Date: December 12, 2003
 To: T10 Committee (SCSI)
 From: Jim Coomes (Seagate)
 Subject: SBC Obsolete Third Party XOR Commands

This is a proposal to obsolete the third party XOR commands.

2 Changes to SBC-2 r11

Figure 0.1 — Update write operation (third-party)

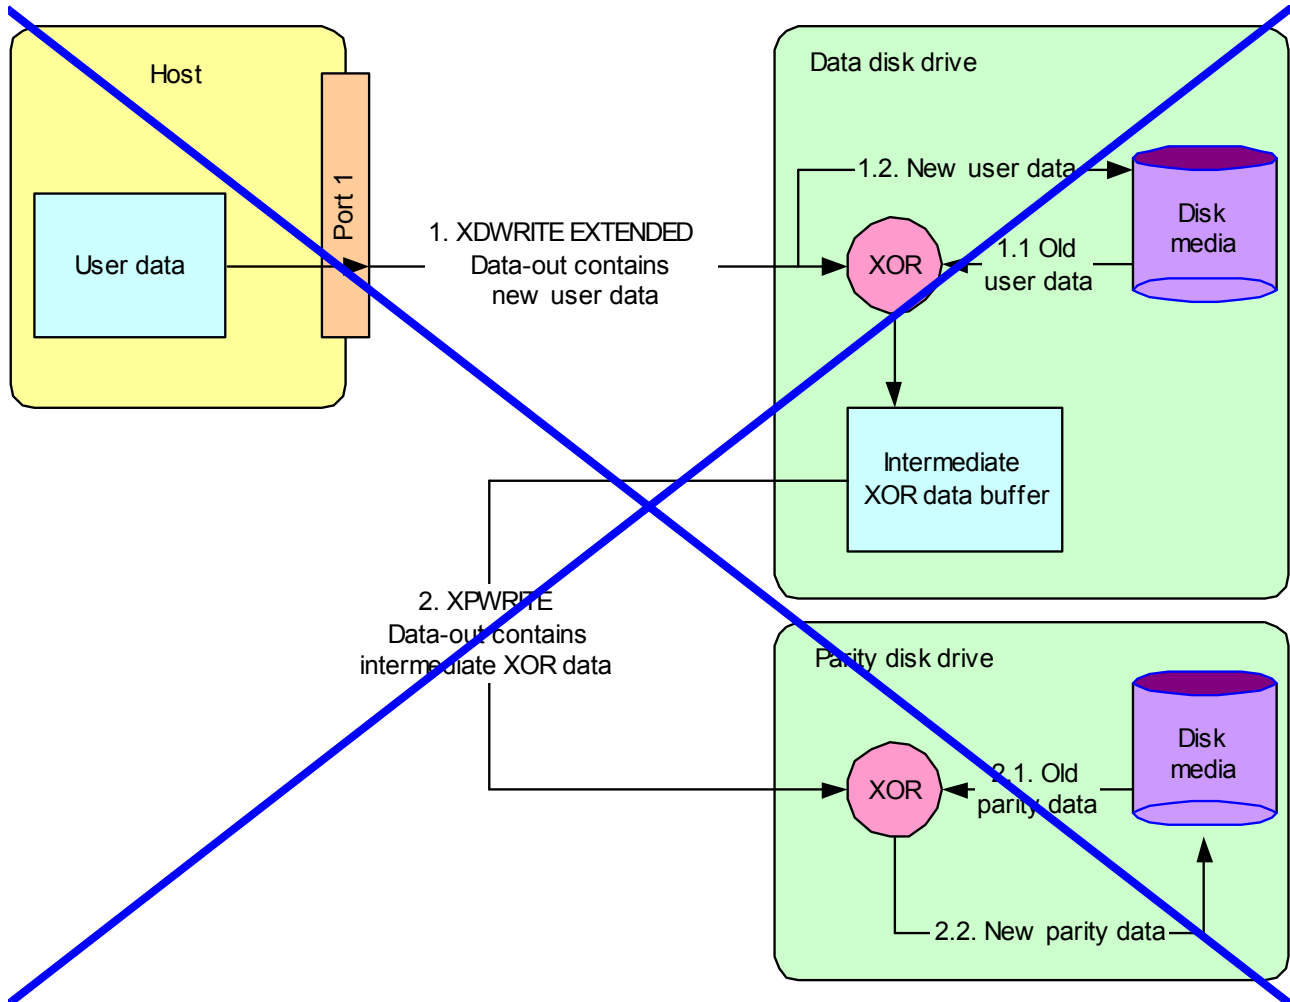
~~0.1 Third-party XOR operations~~

~~0.1.1 Update write operation~~

~~Figure 0.1 illustrates a third party read modify write operation. The example uses a host, a data disk device (holding protected user data), and a parity disk device (holding check data). In this example, the data and parity devices are on the same SCSI physical interconnect, and thus are capable of peer to peer interaction. Two SCSI commands are used: XDWRITE EXTENDED and XPWRITE.~~

Figure 0.2 — Regenerate operation (third party)

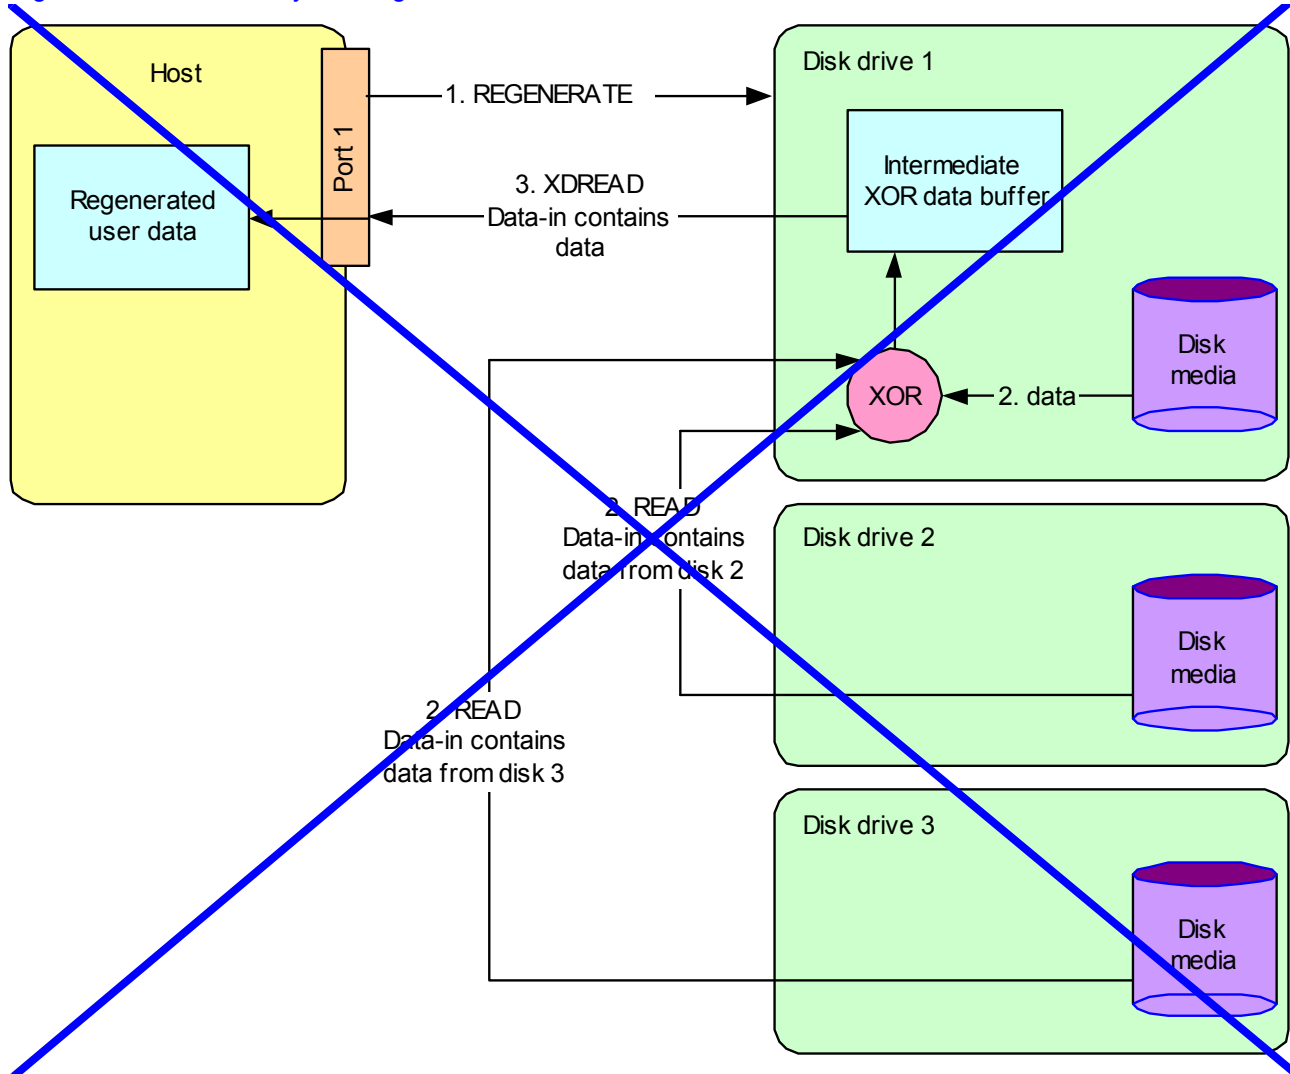
Figure 0.2 illustrates a third-party regenerate operation. The example uses a host and three disk devices. In this example, all three disk devices are on the same SCSI physical interconnect, and thus are capable of peer to peer interaction. Three SCSI commands are used: REGENERATE, READ, and XDREAD.

Figure 0.3 — Rebuild operation (third party)

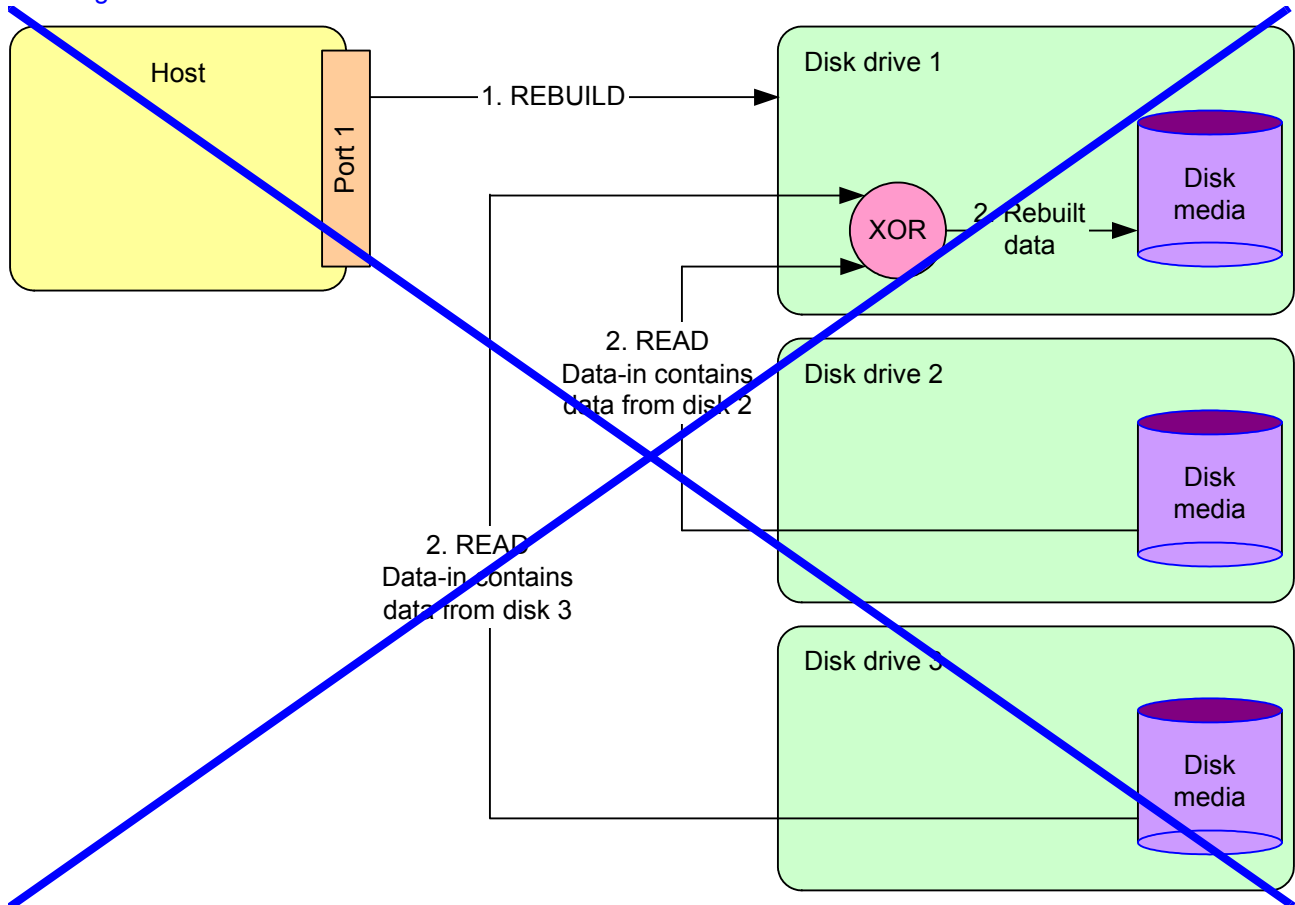
Figure 0.3 illustrates a third party rebuild operation. The example uses a host, two disk devices as the source devices, and one disk device as the device being rebuilt. In this example, all three disk devices are on the same SCSI physical interconnect, and thus are capable of peer to peer interaction. Two SCSI commands are used: REBUILD and READ.
